GAINES CHARTER TOWNSHIP
PLANNING COMMISSION – REGULAR MEETING
Township Board Room - 8555 Kalamazoo Ave. S.E. Caledonia, MI 49316

DRAFT Agenda

7:00 p.m. – Thursday, August 22nd, 2024

Planning Commission Memo

ALEXANDER TRAILS
TENTATIVE PRELIMINARY PLAT
PHASE 1 PLAT / PHASE 2 PLAT / PHASE 1 CONDOS
Phase 1 & 2 - Site Layout Plan

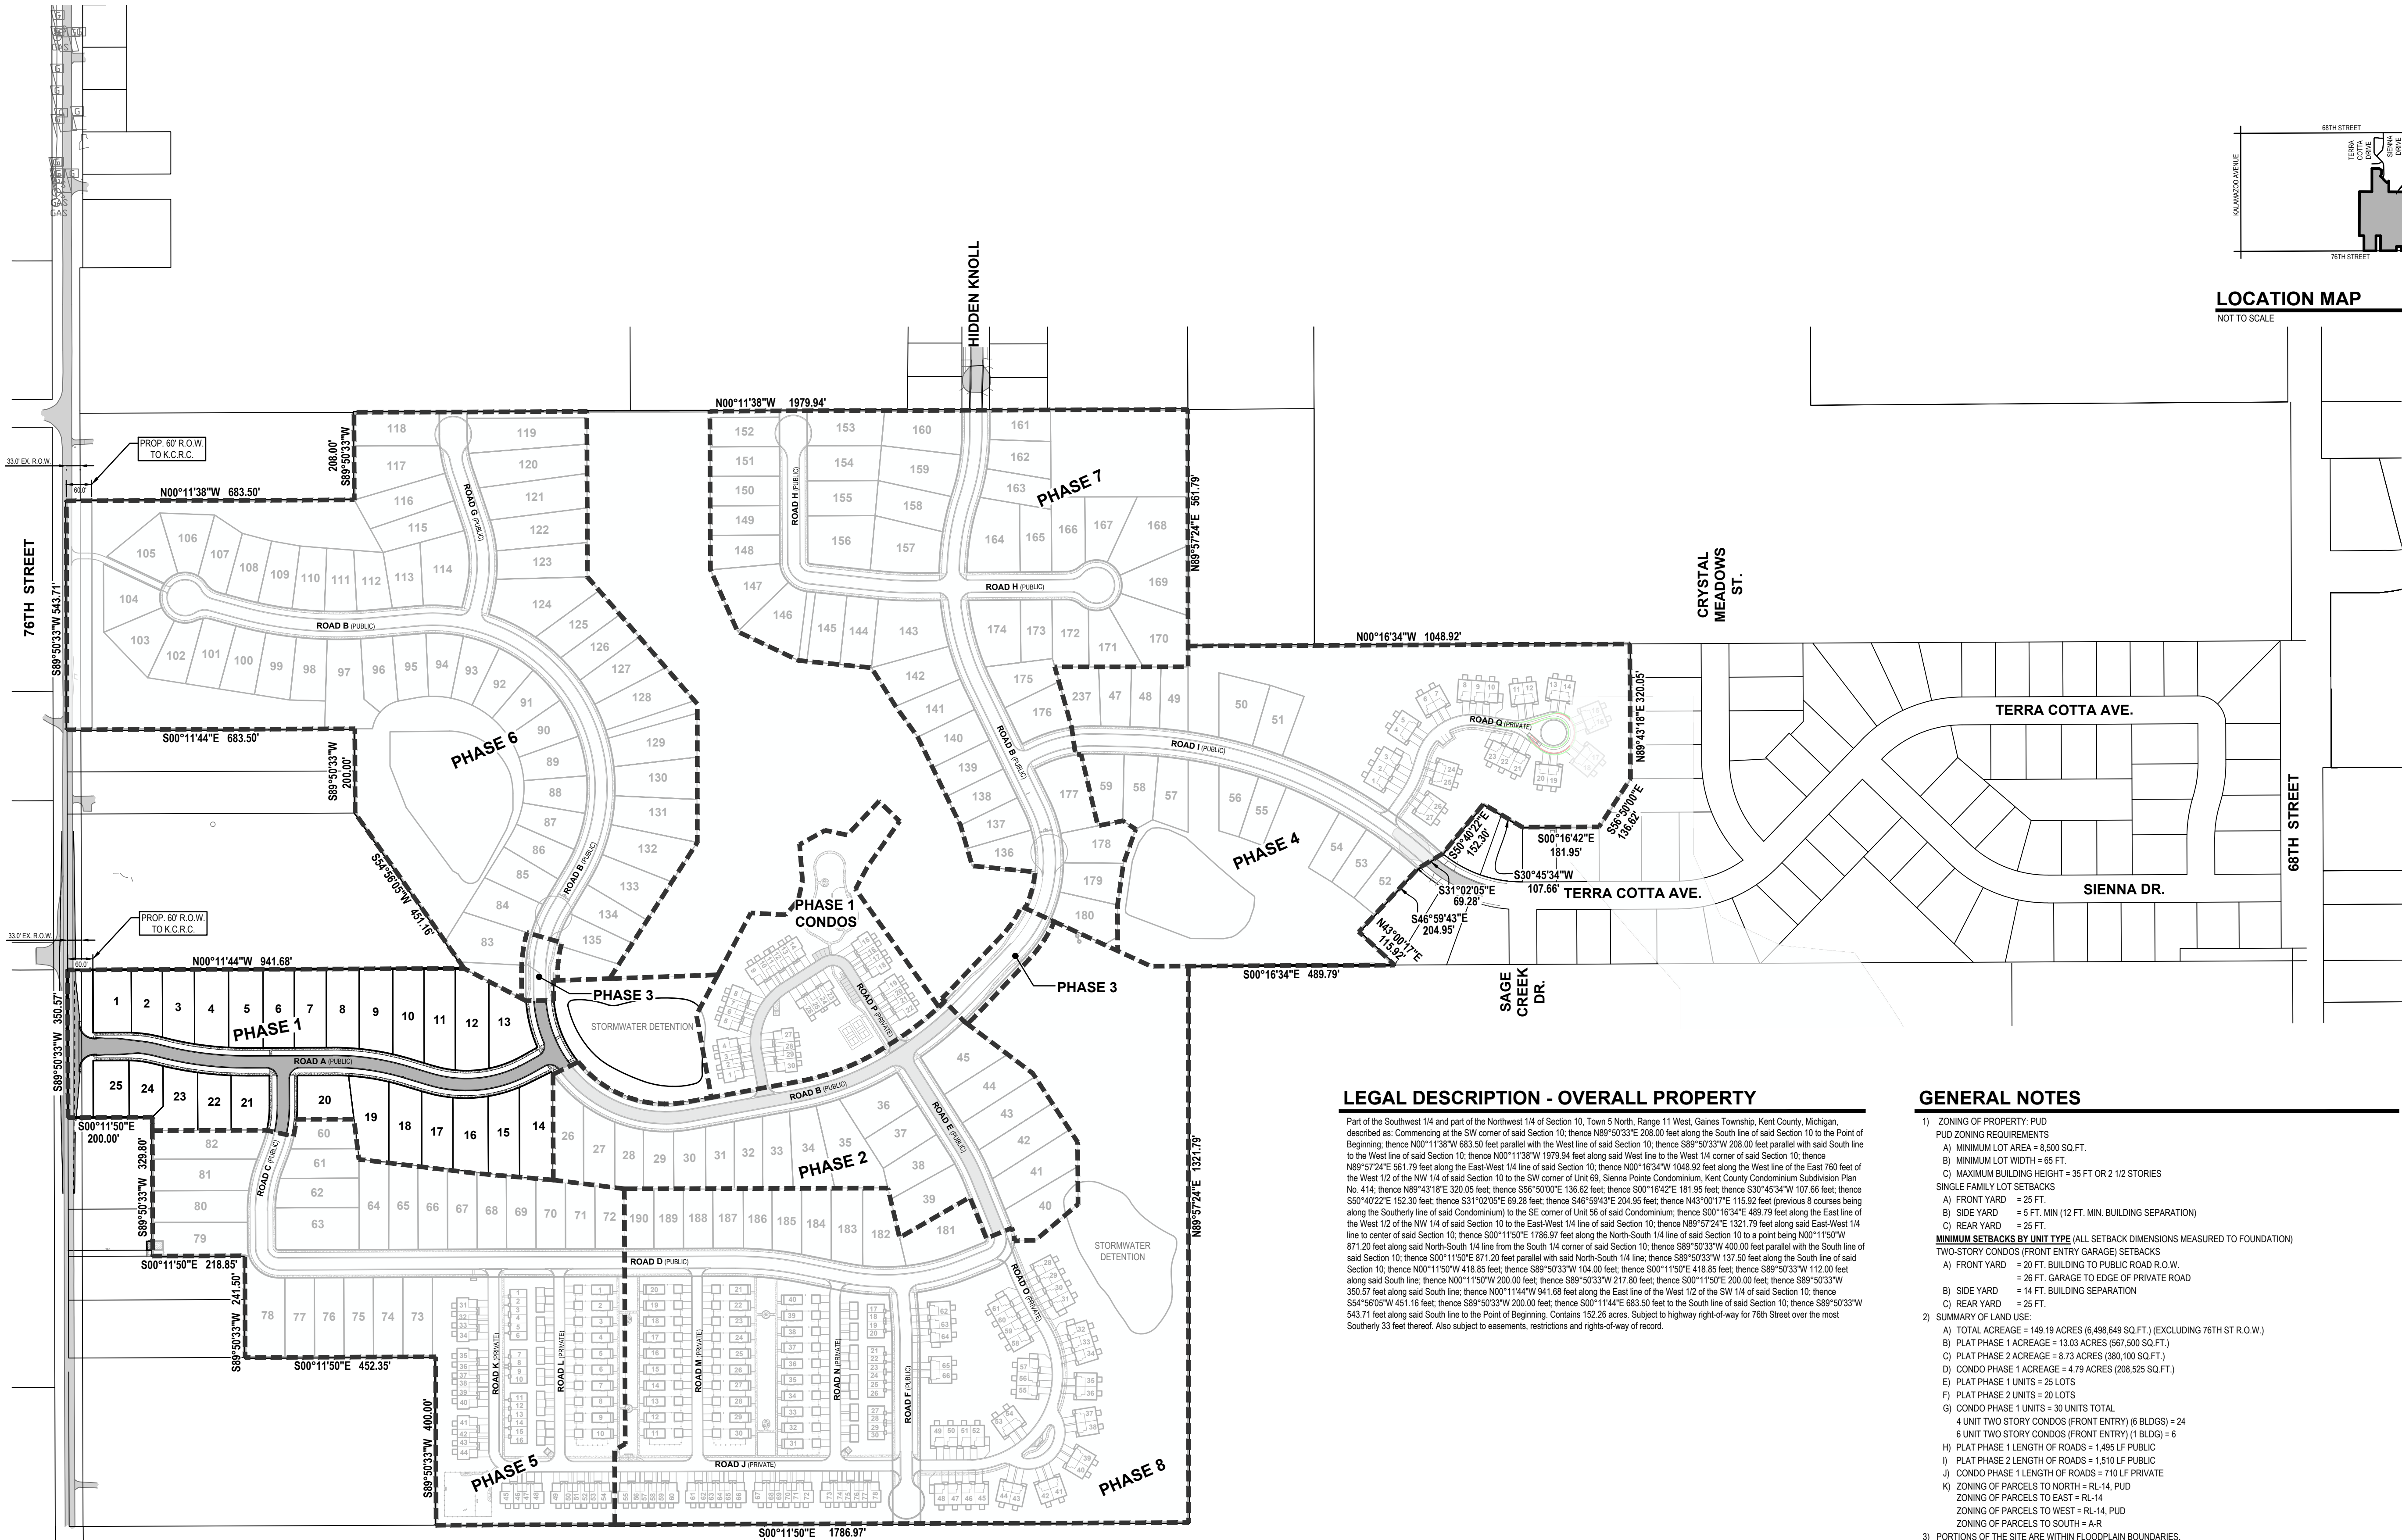
Landscaping plans show street trees planted at ca. 70–140-foot intervals along the streets; landscaping requirements under Section 16.13 Residential Landscaping require one canopy tree for every 80 feet of lot frontage. The landscaping plans show four species to be utilized, staff encourages planting more of a variety of native tree species where feasible and mixing species along road corridors to create diversity in case of loss due to species specific disease.

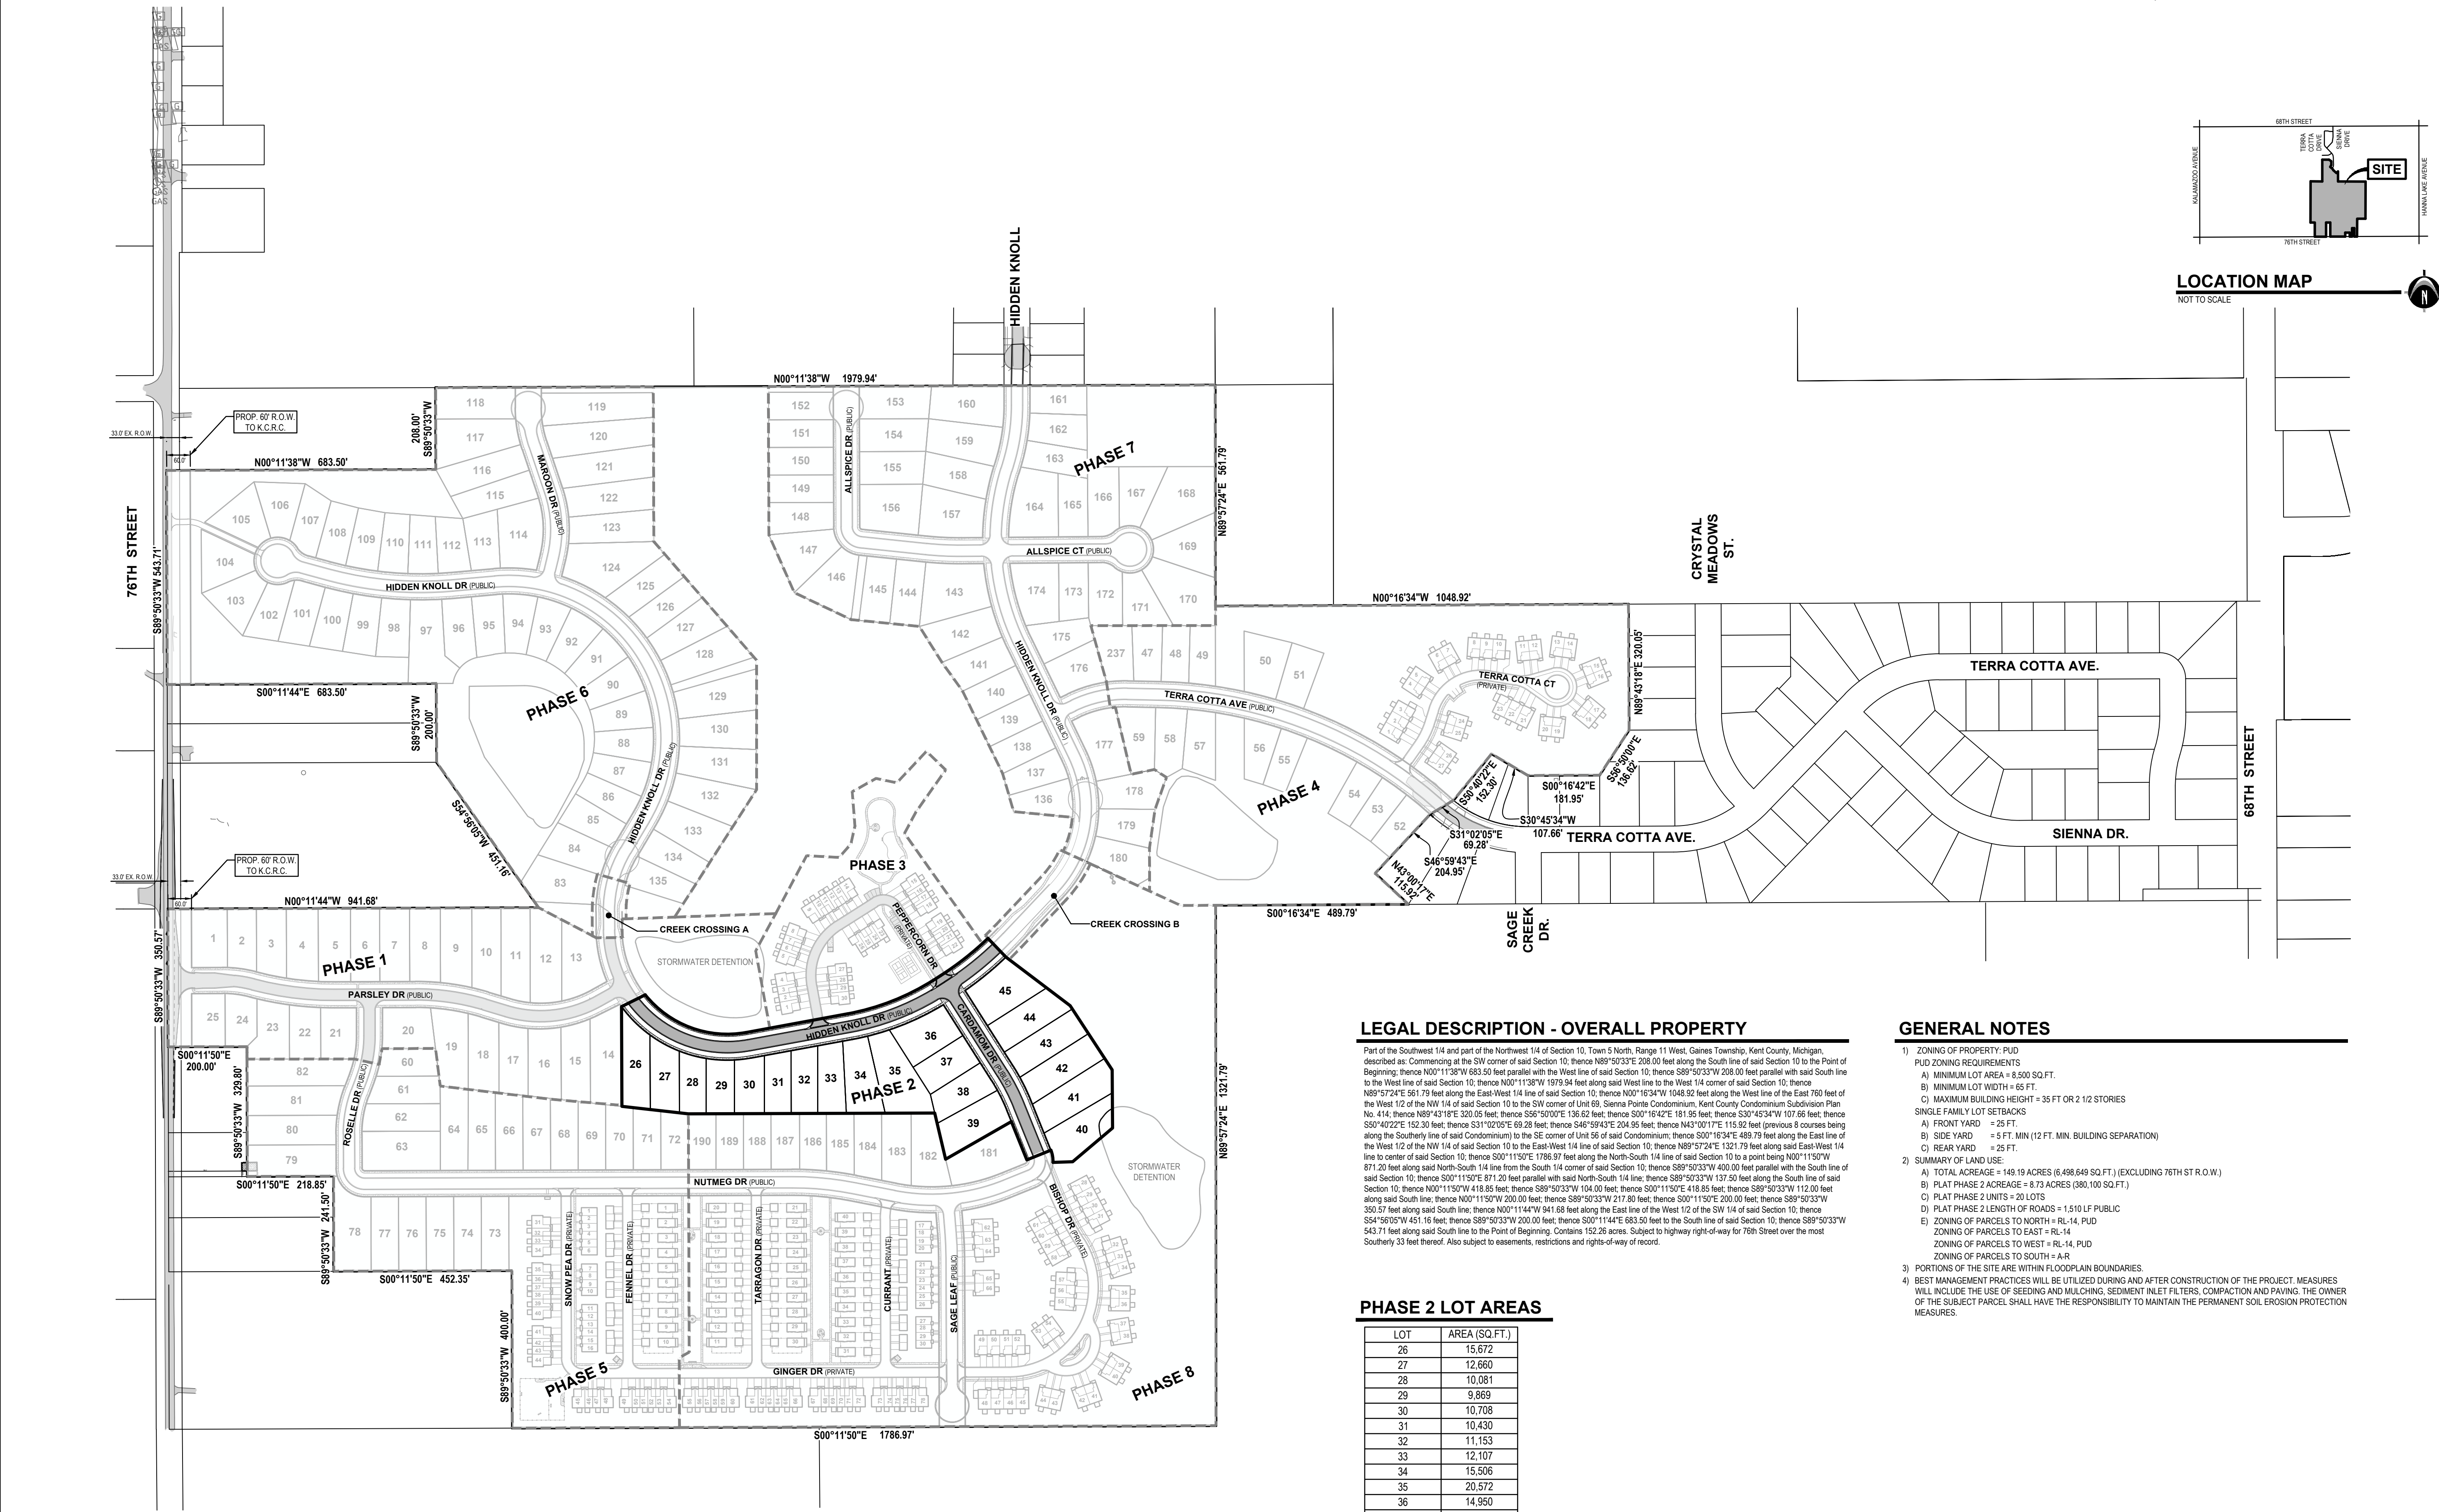
Landscaping plans show street trees planted at ca. 70–140-foot intervals along the streets; landscaping requirements under Section 16.13 Residential Landscaping require one canopy tree for every 80 feet of lot frontage. The landscaping plans show four species to be utilized, staff encourages planting more of a variety of native tree species where feasible and mixing species along road corridors to create diversity in case of loss due to species specific disease.
